ADDENDUM NO. 08

Date of Addendum: 4-11-14

PROJECT NAME: TIGER Project #1 – White Oak Path:
Alabonson Rd. to Antoine Dr. Link

PROJECT NO: WBS No. F-TIGER4-0001-4

WATER	TRAFFIC & TRANSPORTATION
WASTEWATER	STORM WATER QUALITY
STORM	FACILITIES
STREET & BRIDGE	
WBS NUMBER	**CITY DWG NO.**
F-TIGER4-0001-4	
DRAWING SCALE	
VERT. 1" = 2' HORIZ. 1" = 20'	
SHEET NO. 18 OF 122

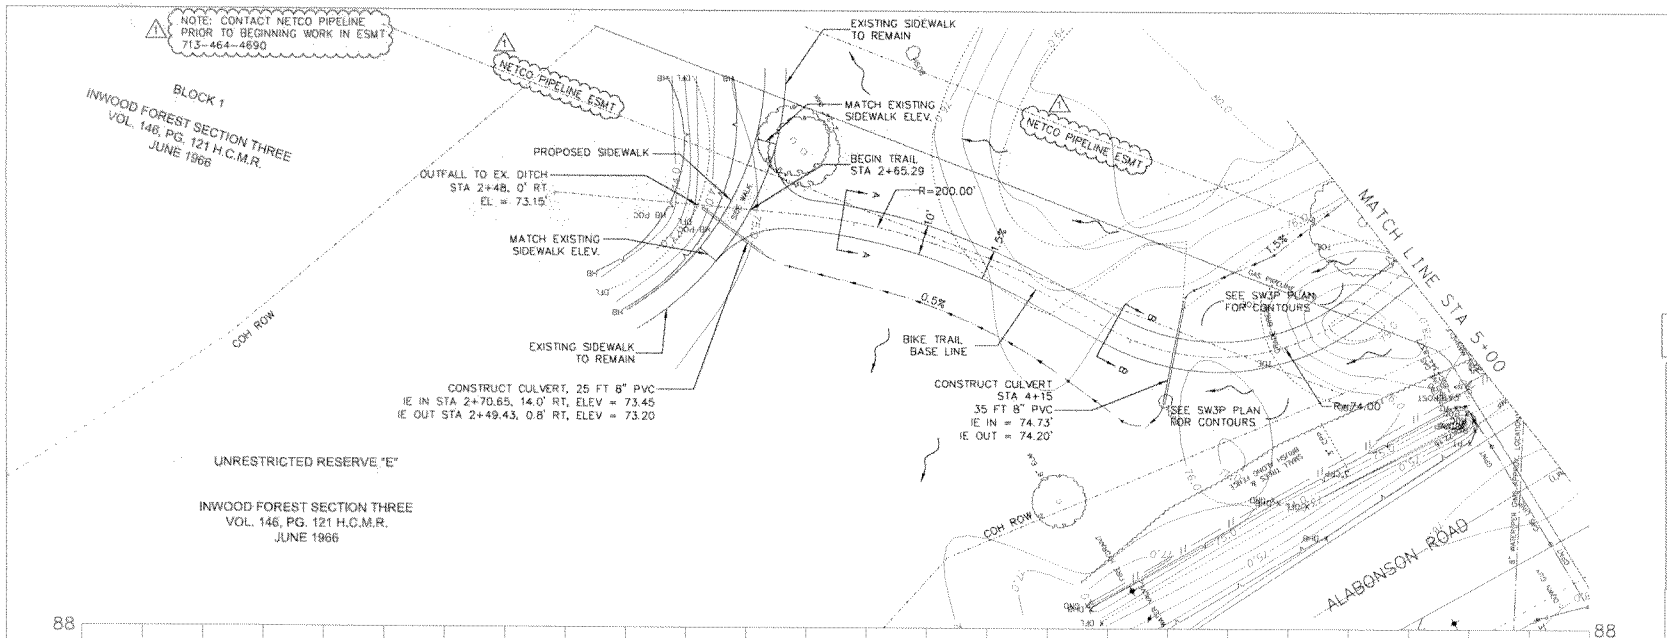
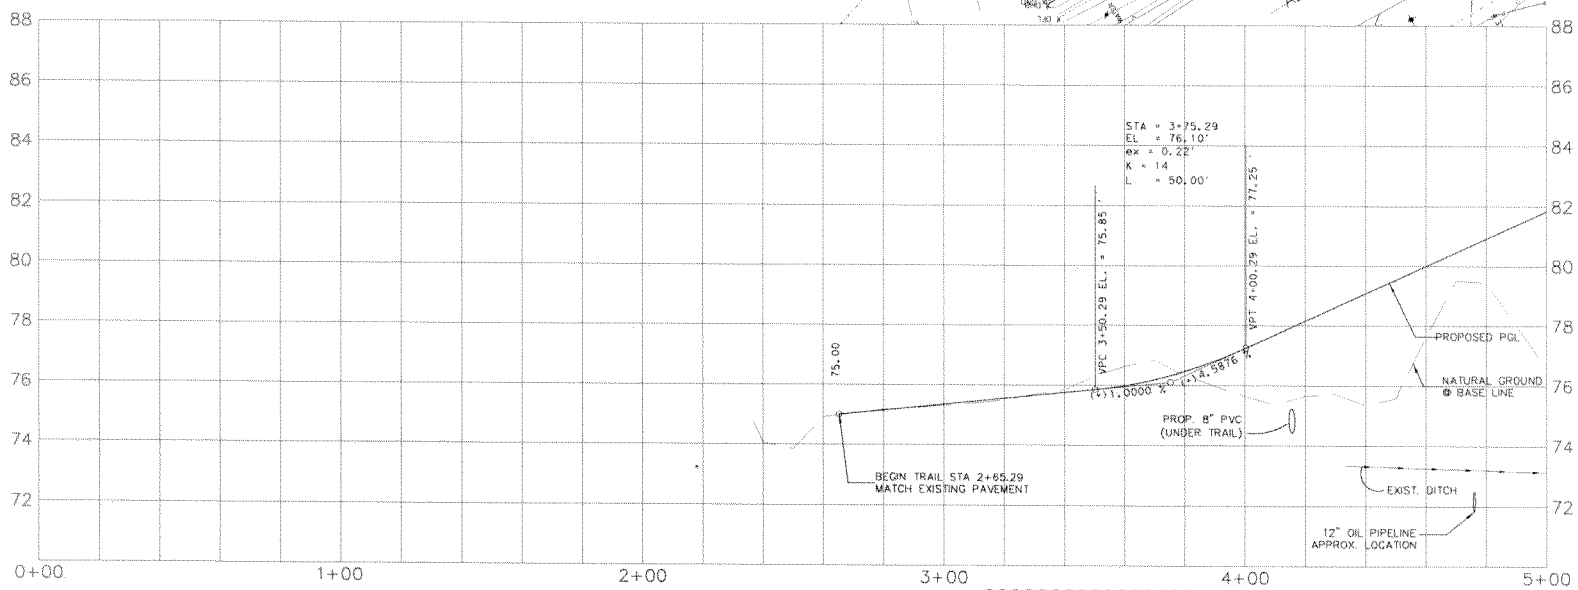
4. Delete Sheet 18, Plan and Profile, and replace with attached Sheet 18. Swale rerouted to outfall into existing Inwood Golf Course ditch instead of Alabonson Road ditch. 24" RCP connection to Alabonson Road ditch removed. 8" PVC culvert added under existing golf course sidewalk to connect to existing ditch. 40 LF of existing golf course sidewalk to be reconstructed after culvert installation.

PLAN AND PROFILE
STA 2+00 TO 5+00

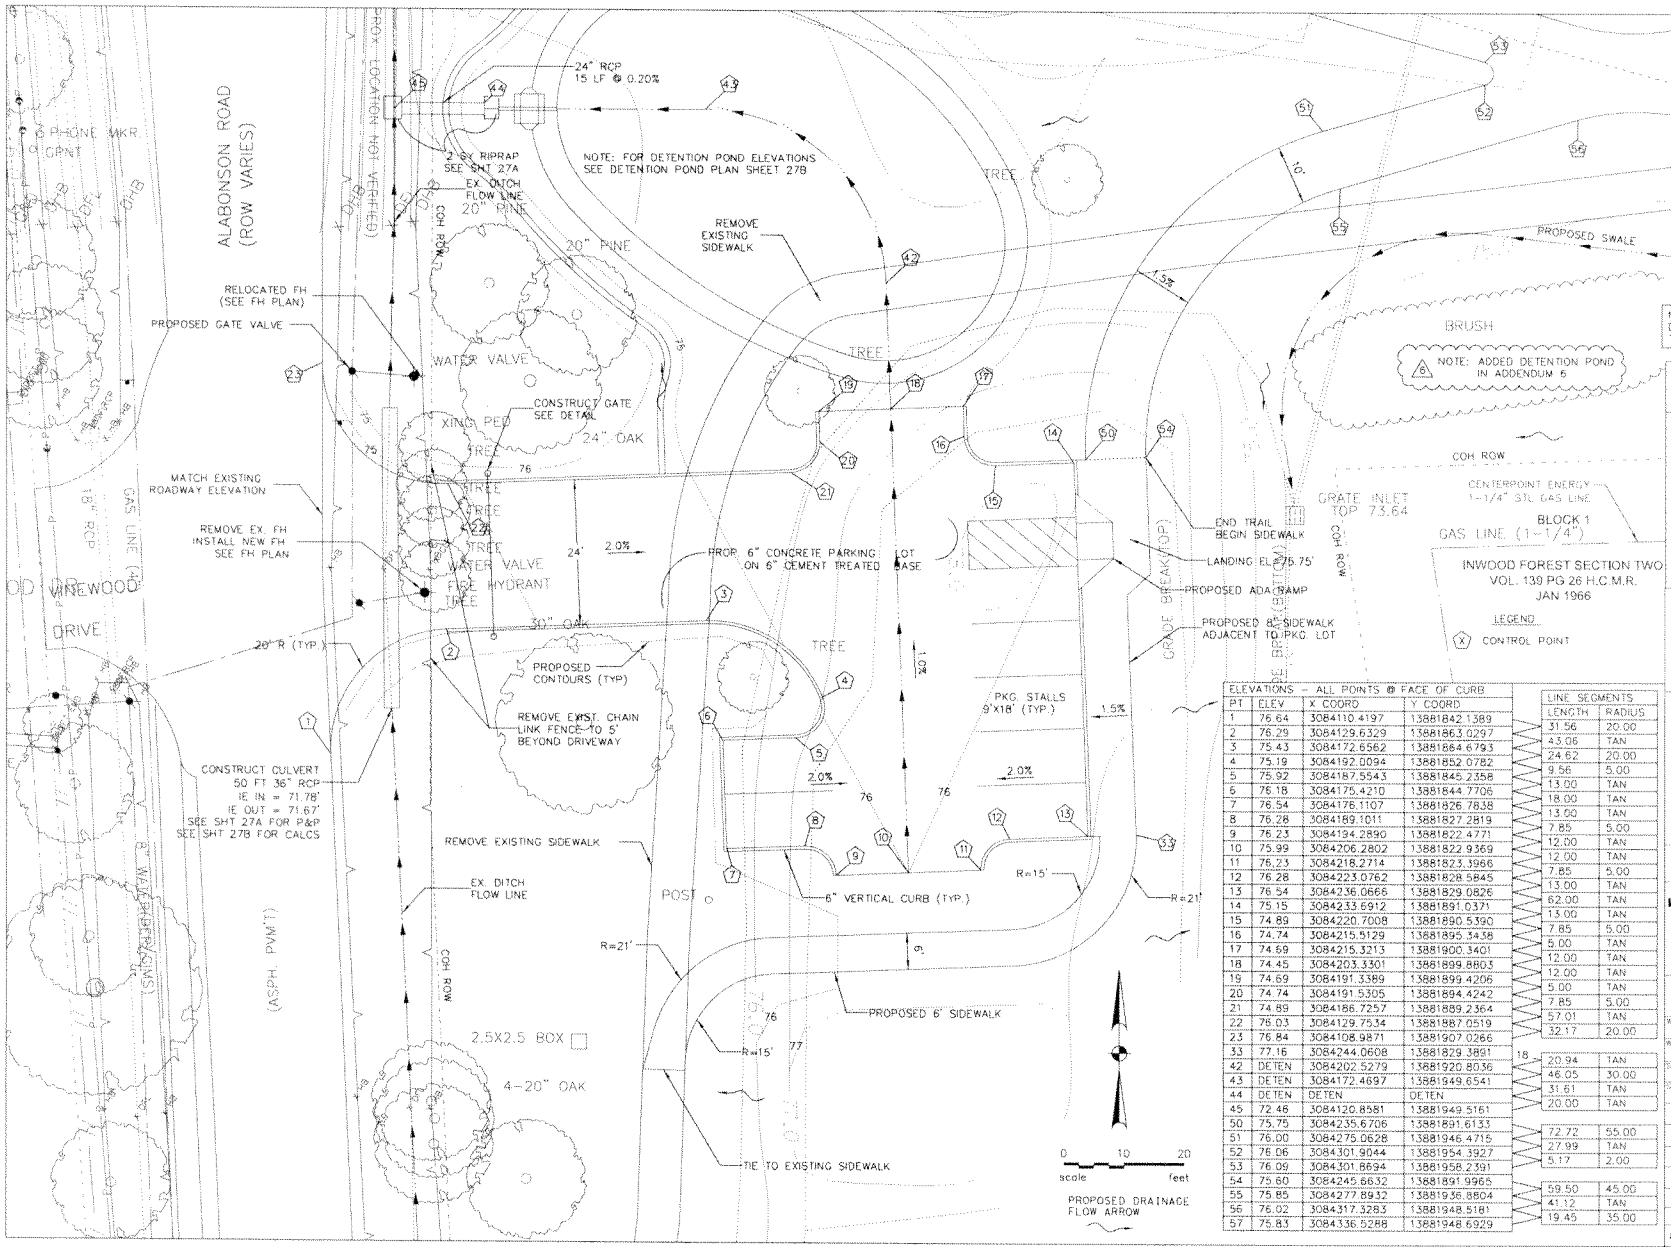
5. Delete Sheet 27, Alabonson Road Trailhead Grading Plan, and replace attached Sheet 27. Detention pond flow restrictor changed from dual 2" PVC to single 6" PVC. Riprap added to both ends of 24" RCP outfall to existing Alabonson Road ditch. Some callouts added/changed to refer to sheet 27A or 27B. Sheet title has changed.

SHEET NO. 27A OF 122

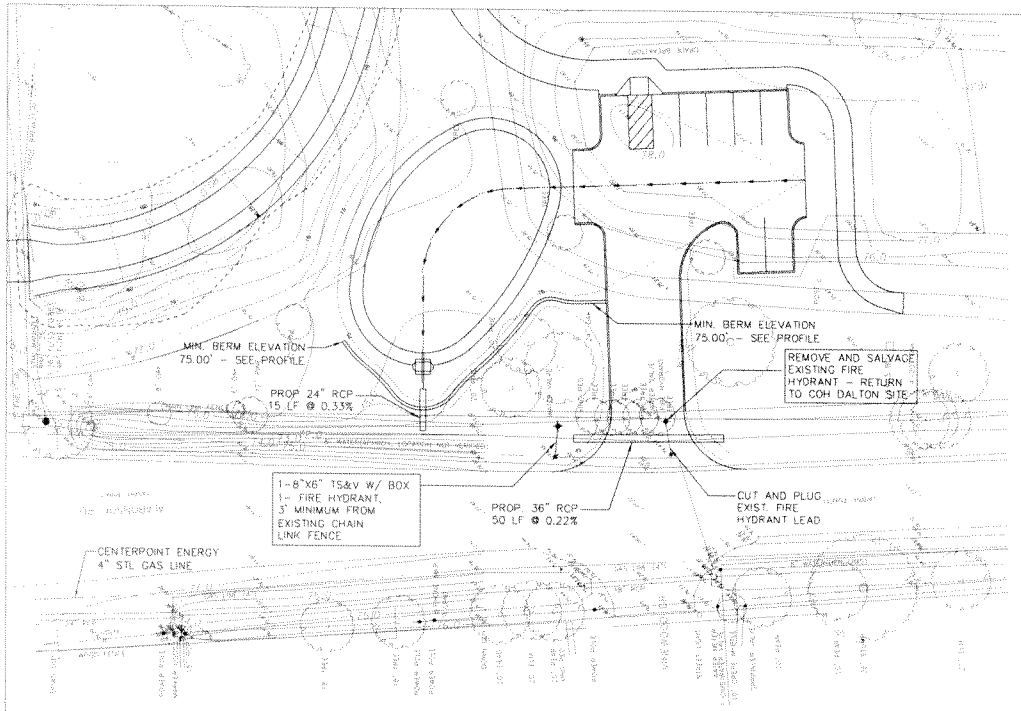
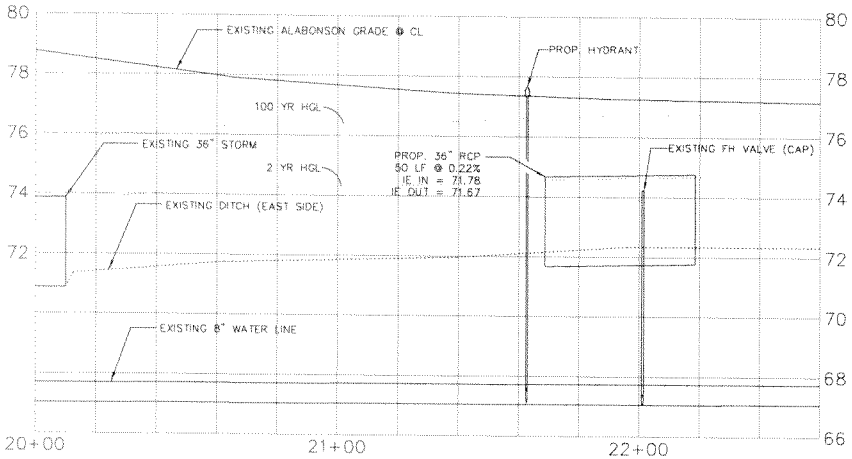
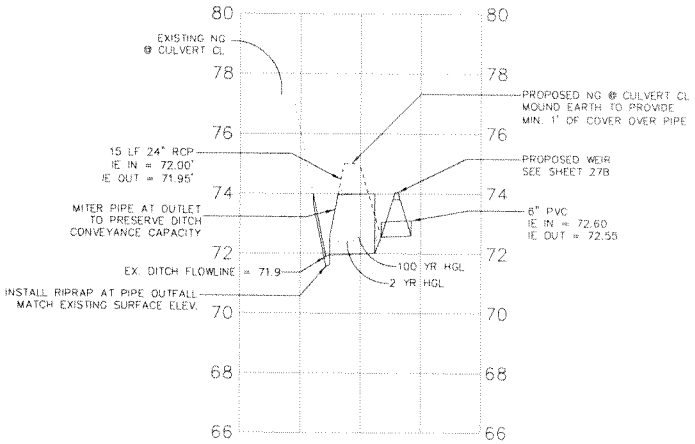
6. Delete Sheet 27A, Alabonson Road Trailhead Fire Hydrant Relocation and Storm Profile, and replace attached Sheet 27A. Sheet 27A has been replotted at 1:20 horizontal and 1:2 vertical. A profile of the proposed 24" RCP outfall to existing Alabonson Road ditch has been added. Said 24" outfall has been lowered. Sheet title has changed.

NOTE: REVISED SHEET 27A (JUSTIN) PROVIDED AT REQUEST OF COH STORM REVIEWER SEE DATE 4-11-2014 EMAIL AT 13:06 FOR DISCREPANCY WITH STAKE SEDIMENTS.

SHEET NO. 27B OF 122

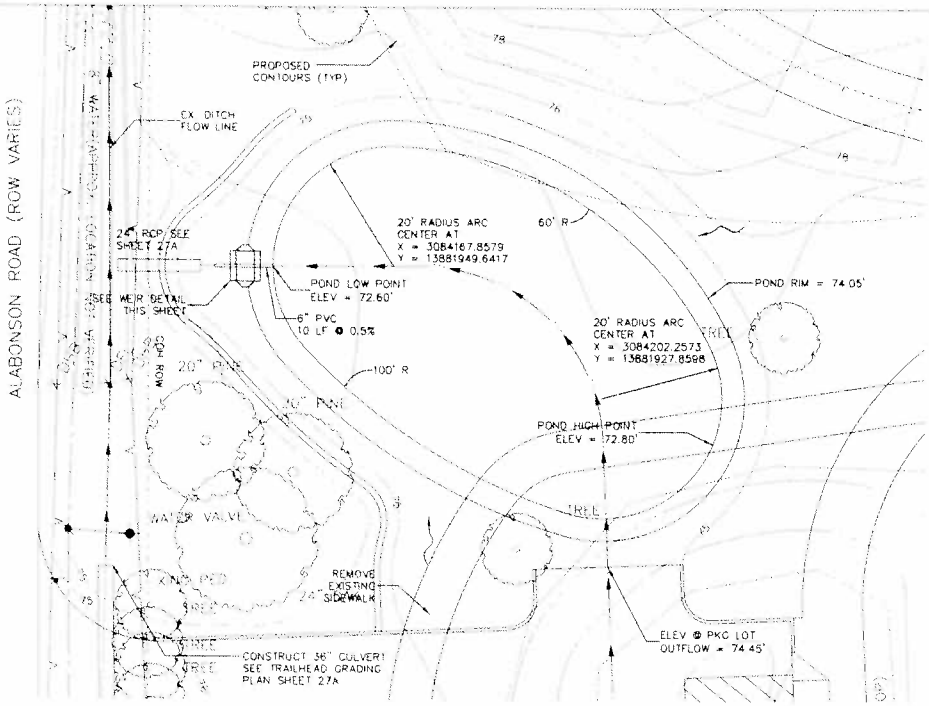
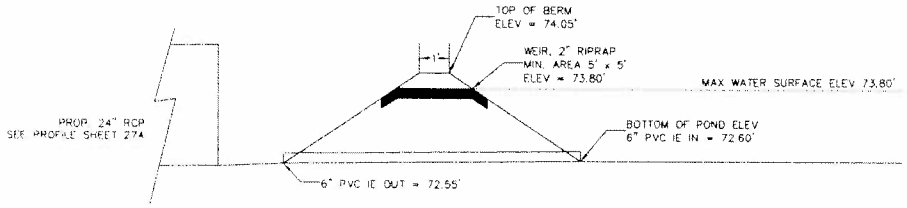
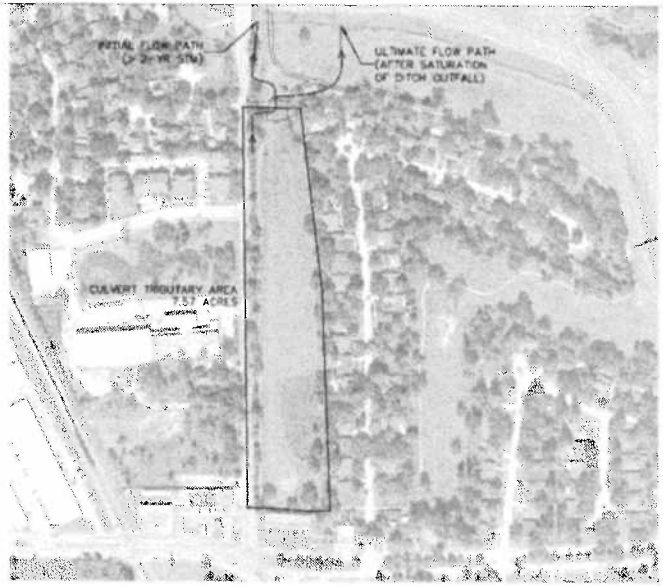
7. Delete Sheet 27B, Alabonson Road Trailhead Detention Design and Stormwater Calculations, and replace attached Sheet 27B. Profile of weir cropped to no longer show existing ditch flowline. This information has been added to sheet 27A. Callout added to this effect. Riprap added to both ends of lowered 24" RCP (same pipe as on 27A). Sheet title has changed.

SHEET NO. 48 OF 122

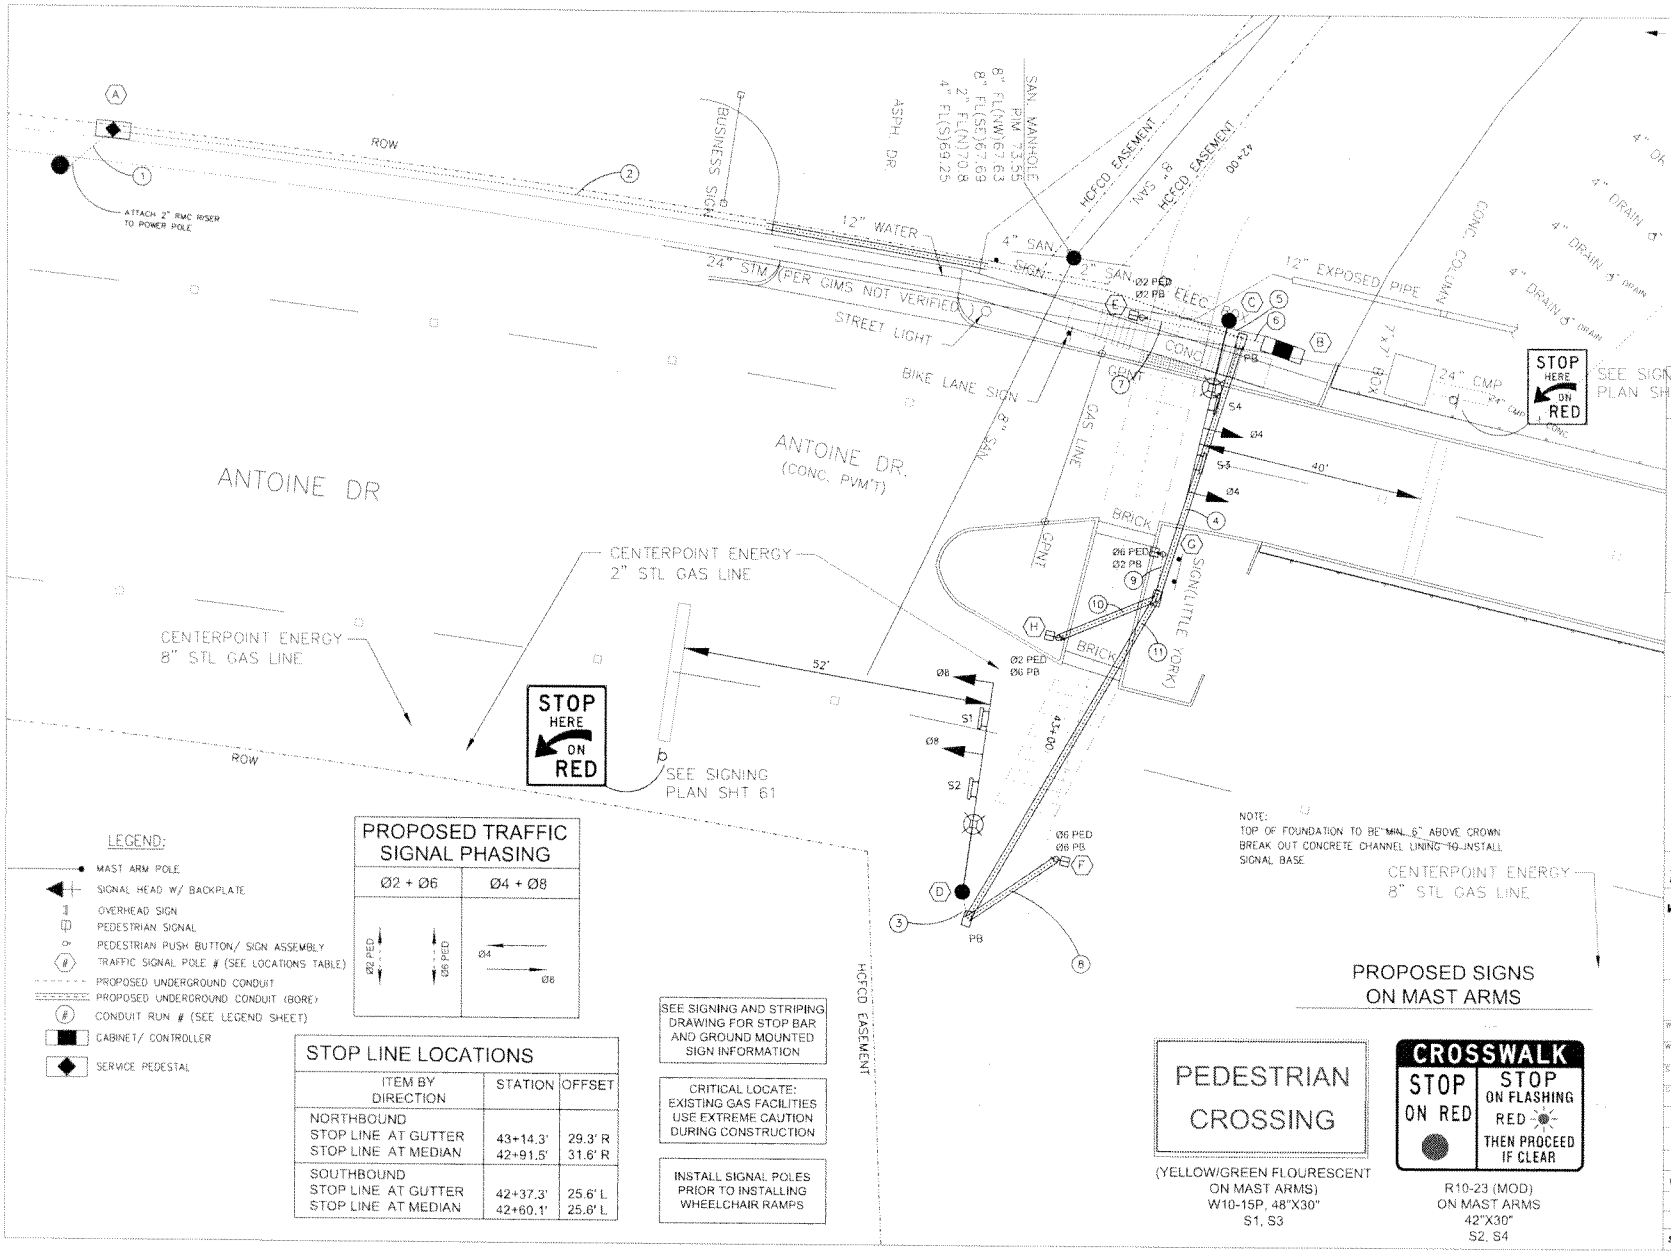
8. Delete Sheet 48, Antoine Pedestrian Hybrid Signal Layout, and replace with attached Sheet 48. Median pushbutton phase updated per Transtar request. Additional reference to R10-6a "Stop Here On Red" signs added. Reference signing plan (unchanged) for installation details.

SHEET NO. 49 OF 122

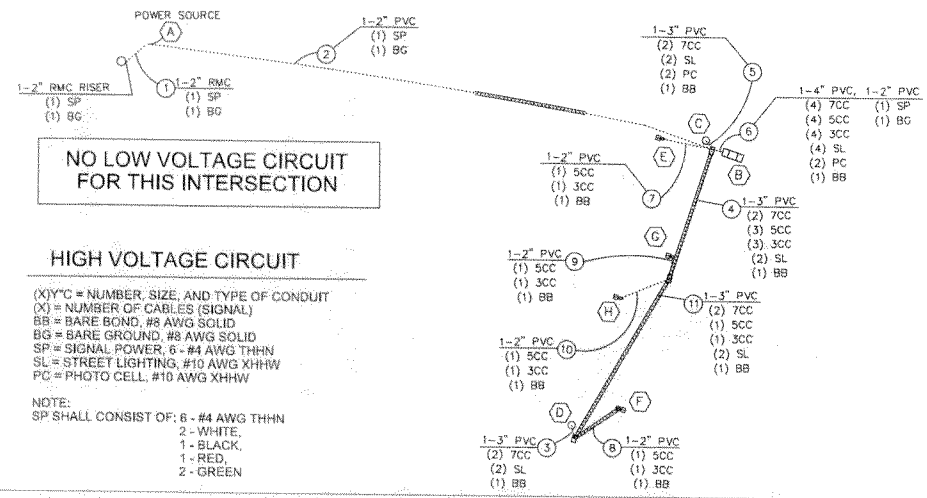
9. Delete Sheet 49, Antoine Pedestrian Hybrid Signal Pole Schedule & Cable Schematic Sheet, and replace with attached Sheet 49. Notes added regarding ITS installation/preservation.
